# Work Order ID 95500

Item Name: Crosstube Fwd High

<b>DART AEROSPACE LTD</b>	<b>Work Order:</b>	95100
<b>Description:</b> Crosstube High Fwd (205/212/412)	<b>Part Number:</b>	D212-664-101
<b>Inspection Dwg:</b> D212-664-141 <b>Rev:</b> D		<b>Page 1 of 1</b>

DRAWING NO. D212-664-141	TITLE XTUBE ASSY (205/212/412 HI FWD)	REV. D	DART AEROSPACE LTD ENGINEERING ORDER		D.E.O. NO. D212-664-141-D-1	SHEET NO. SHEET 1 OF 2	SCALE NTS
DRAWN	CHECKED	MFG. APPR.	APPROVED	DE APPR.			
DATE 11.04.07	DATE 11.04.11	DATE 11.04.12	DATE 11/04/12	DATE 11.04.12

DRAWING NO. D212-664-141	TITLE XTUBE ASSY (205/212/412 HI FWD)	REV. D	DART AEROSPACE LTD ENGINEERING ORDER	D.E.O. NO. D212-664-141-D-1	SHEET NO. SHEET 2 OF 2	SCALE NTS
DRAWN	CHECKED	CP	MFG. APPR.	APPROVED	DE APPR.	
DATE 11.04.07	DATE 11.04.11		DATE 11.04.12	DATE 11/04/12	DATE 11.04.12

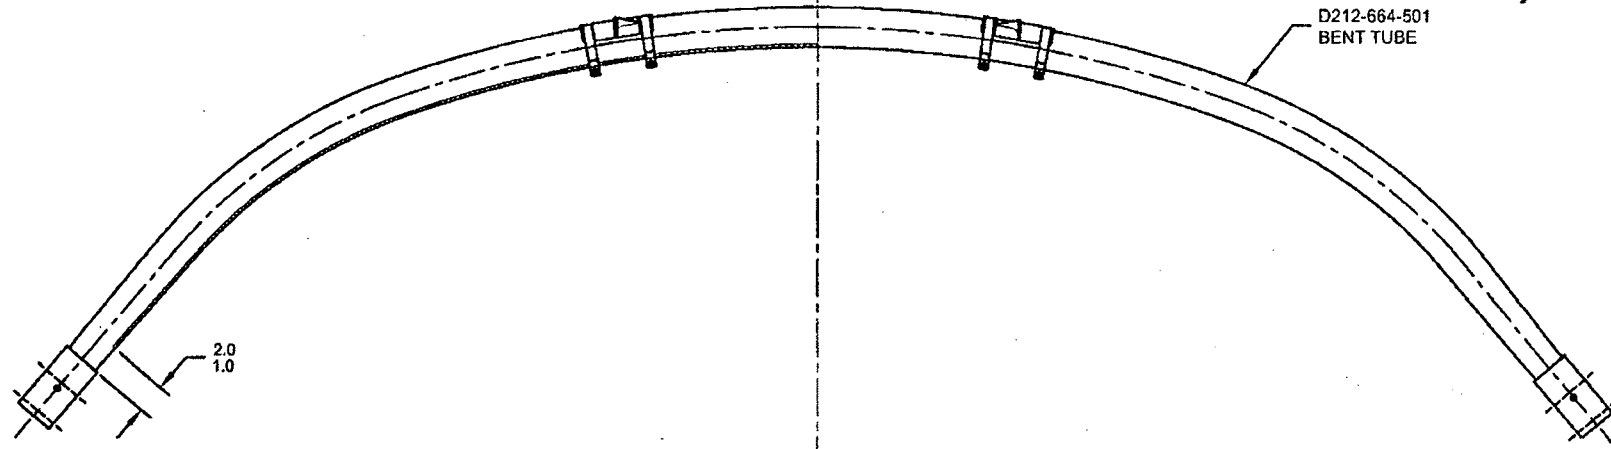
ADD AN INSPECTION WINDOW TO UNDERSIDE OF CROSSTUBE.

NOTES 2 OF SHEET 1 IS AMENDED AS FOLLOWS:

- 2) FINISH: CHEMICAL CONVERSION COAT PER DART QSI 005 4.1  
PRIME INSIDE AND OUTSIDE PER DART QSI 005 4.2  
MASK UNDERSIDE OF CROSSTUBE AS SHOWN (HATCHED AREA) AND  
PAINT OUTSIDE PER DART QSI 005 4.2  
REMOVE MASKING AND APPLY CLEAR COAT

MASK AREA PRIOR TO PAINTING,  
REMOVE MASKING AFTER PAINT  
AND APPLY CLEAR COAT
